Subject: Three Mile Island Nuclear Generating Station, Unit 1 (TMI-1)
Operating License No. DPR-50
Docket No. 50-289
Response to Request for Additional Information - Core Reload
Methodology

NRC letter dated August 23, 1995 requested additional information regarding GPU Nuclear Topical Report TR-091, Revision 0, "Steady State Reactor Physics Methodology for TMI-1." This Topical Report was submitted by GPU Nuclear on March 6, 1995 for NRC review and approval for in-house GPU Nuclear core reload design.

Figure 1 Power Imbalance Alarm Limits
(0-to-75 EFPD and 4 Pump Operation)

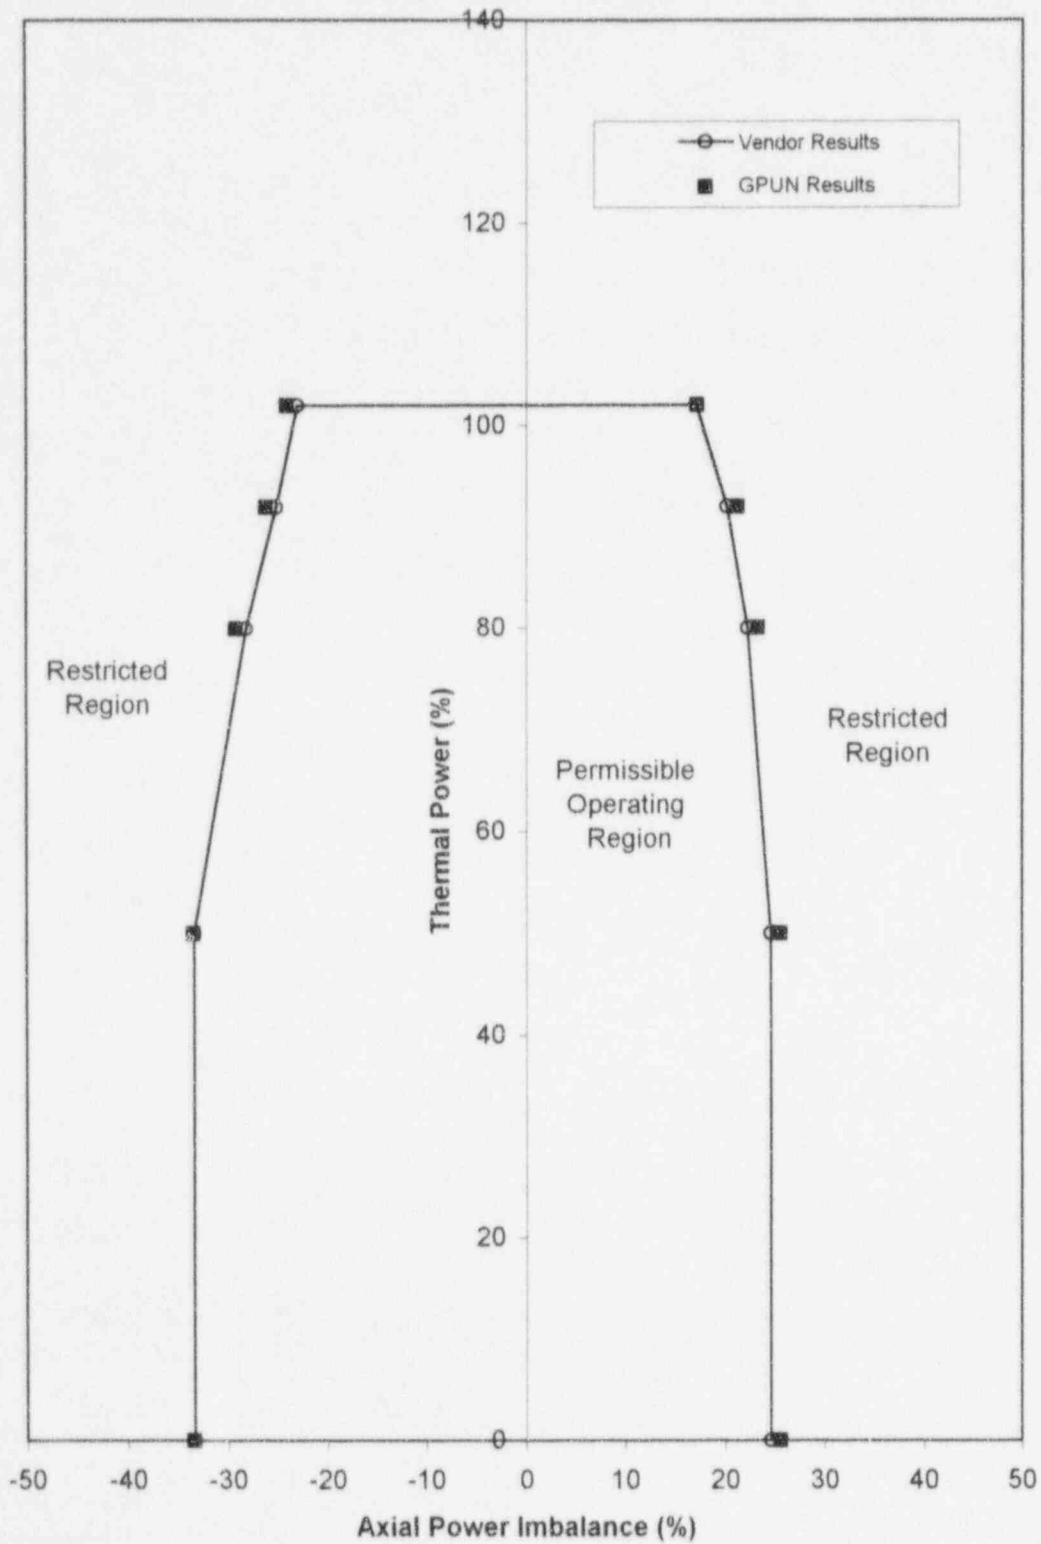
4. **What effect will the use of these new reliability factors have on existing plant operating limits?**

Since the reliability factors determined in TR-091 are either the same or close to the current values (see answers to Questions 2 and 3), the impact of using the new reliability factors on existing plant operating limits is insignificant. As shown in the attached Figures 1 and 2, the power imbalance alarm limits and control rod insertion limits generated with GPU Nuclear methodology are essentially the same as the

vendor results. The Cycle 10 limits are determined using the following reliability factors:

Reliability Factor	GPUN	Vendor
Regulating CR Group Worth	-10%	-10%
Radial Pin Peak	1.038	1.038
Total Pin Peak	1.055	1.048
